## UNICODE FORUM PROPOSED CHANGES – MONGOLIAN BLOCK January 14, 2015

#### **SUMMARY**

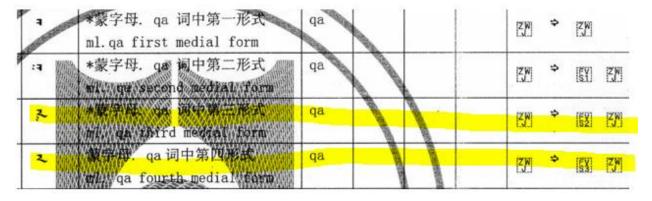
13.) New FVS4 assignment at <U+182D><U+180F> This default form is needed with FVS assignment to over-ride native context for such rare cases as COGAGULA.
